# Installation of New ALPS Treated Water Dilution/ Discharge Facilities and Related Facilities

March 10, 2022

Tokyo Electric Power Company Holdings, Inc.

## **Responses to issues pointed out\* at the review meeting, etc.**

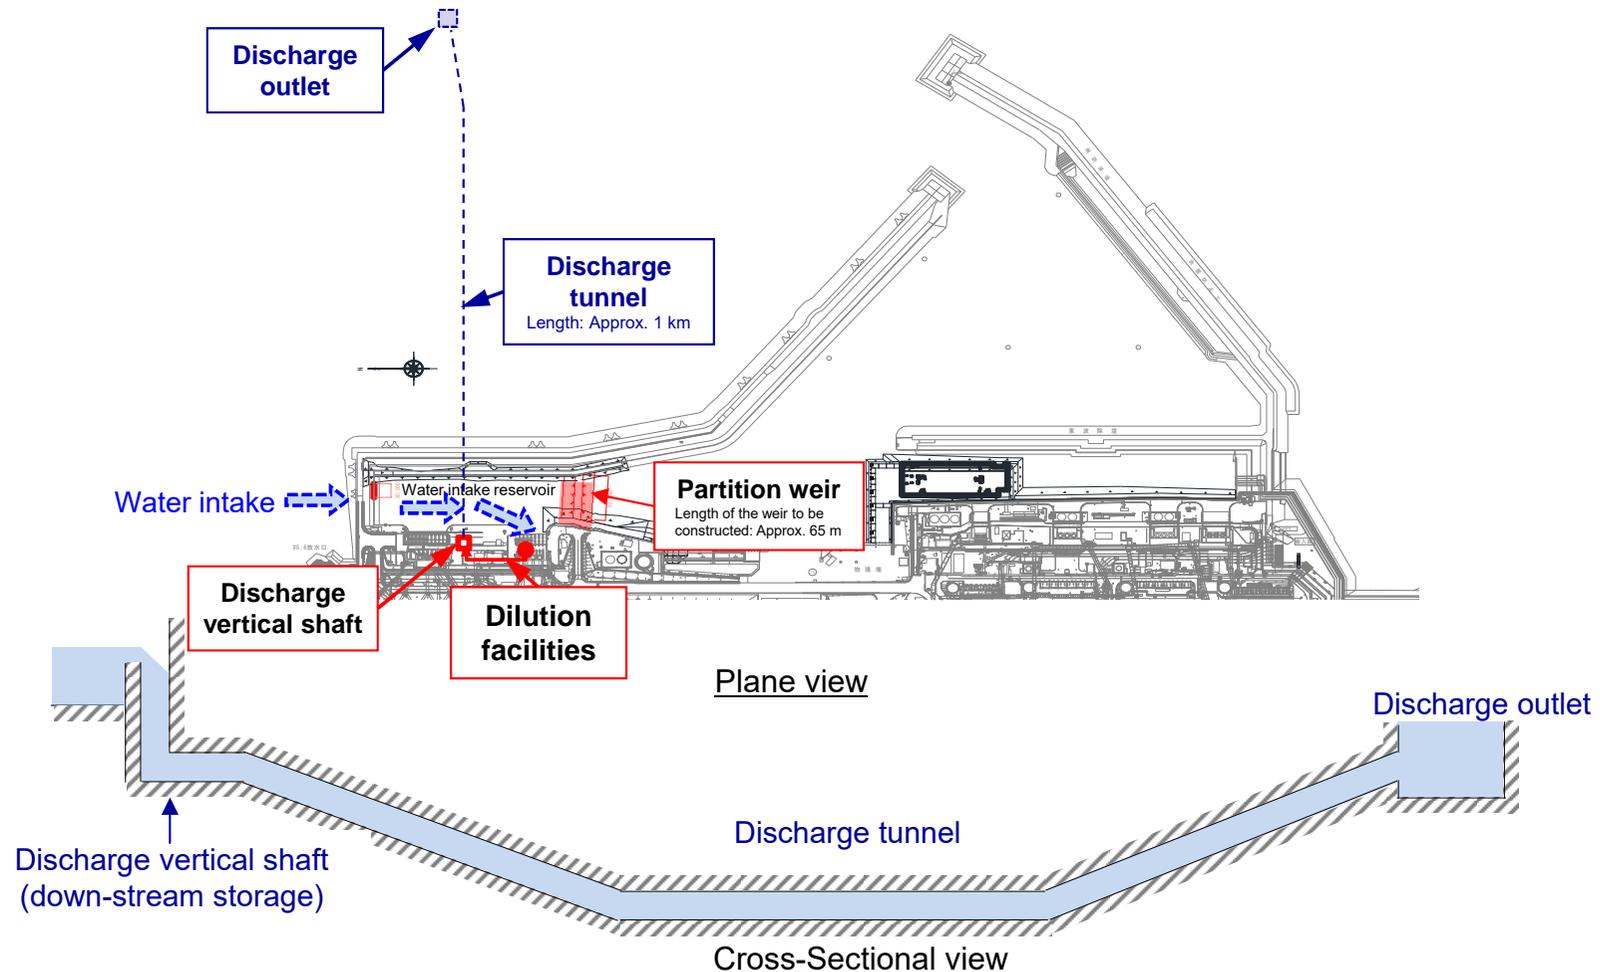
- Regarding construction requiring undersea work, including installation work of a partition weir and a discharge outlet caisson, an explanation should be given on measures to suppress swirl-up of seabed soil and its monitoring during the construction period, response if there are significant changes in the monitoring, and the effects in the event of actual swirl-up of seabed soil.

- Regarding the design of intake facilities, a Units 5-6 intake open-channel will be separated with a partition weir (riprap sloping weir + sheet) from the units 1-4 side port side, and a part of the north breakwater permeation prevention work will be remolded so that the seawater for dilution is taken in from outside the port.
- Discharge facility is designed so that they can transfer water flowing out over the partition wall in the discharge vertical shaft to the outlet, which is approximately 1 km away, by making use of the head between water in the discharge vertical shaft (down-stream storage) and the sea surface. In addition, friction loss in the Discharge facility and increase in water level are taken into account when designing.

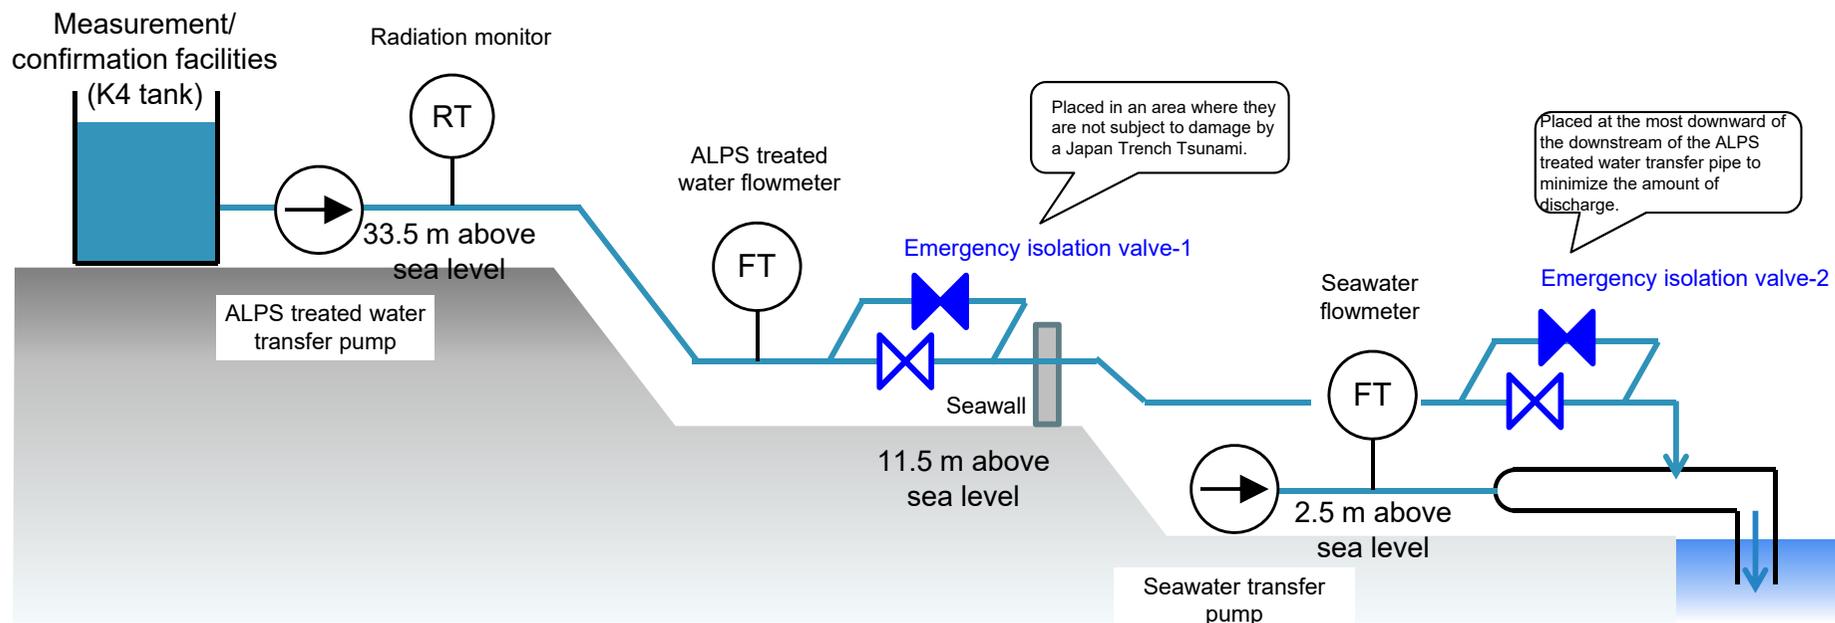
- Explain including entire scope (installation locations of MO valves) and the closing time, because there are many MO valves of the same type as the emergency isolation valve-1 (MO valve).
- In the event of a single failure of the driving source (compressed air), the emergency isolation valve-2 (AO valve) will close, in contrast, water will continue to flow in to the tank through the three-way valve. How to deal with this situation must be explained.

- The operating conditions under which the emergency isolation valve is “closed” are shown in the figure below, designed to prevent “unintentional discharge of ALPS treated water into the sea.”
- The logic is that when various kinds of abnormalities are detected, the sound seawater transfer system will continue the operation and dilution as much as possible.

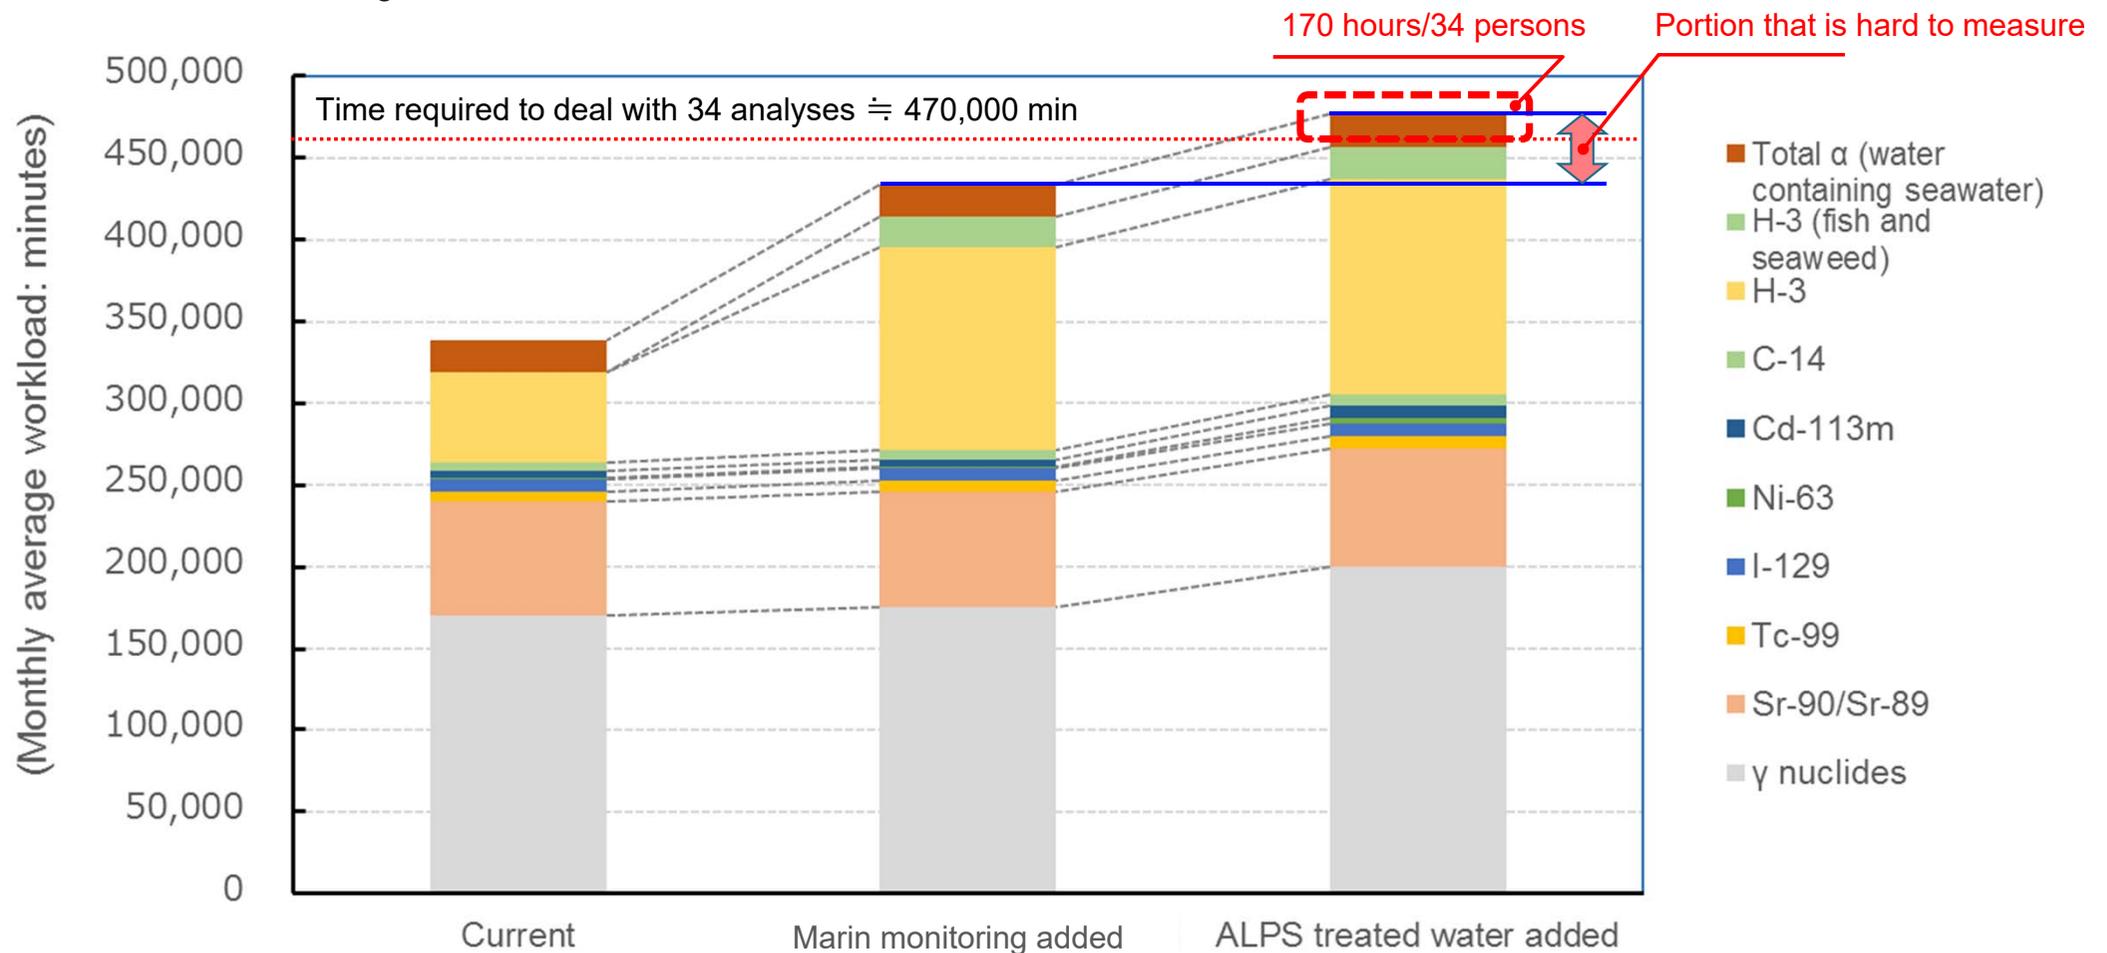
- The overall picture of analytical work must be explained, including required resources, details, time and frequency of analyses for conventional routine analyses that have been performed, analyses work of transient situations in emergencies, and the analysis of ALPS treated water, which will be added this time. Then, an explanation should be given on what role and impact the analysis of ALPS treated water will have in the overall analytical work and how the resources are secured.

- The [chemical analysis building] will have to deal with an increased number of test samples as the discharge of ALPS treated water. After clarifying the resources required, plans for necessary measures will be developed.
- For liquid sample analyses at the time of trouble on site, such as leakage, will not be involved in the chemical analysis building because the property and radioactivity of the liquid are unknown. Therefore, no need to keep resources for responding to troubles.
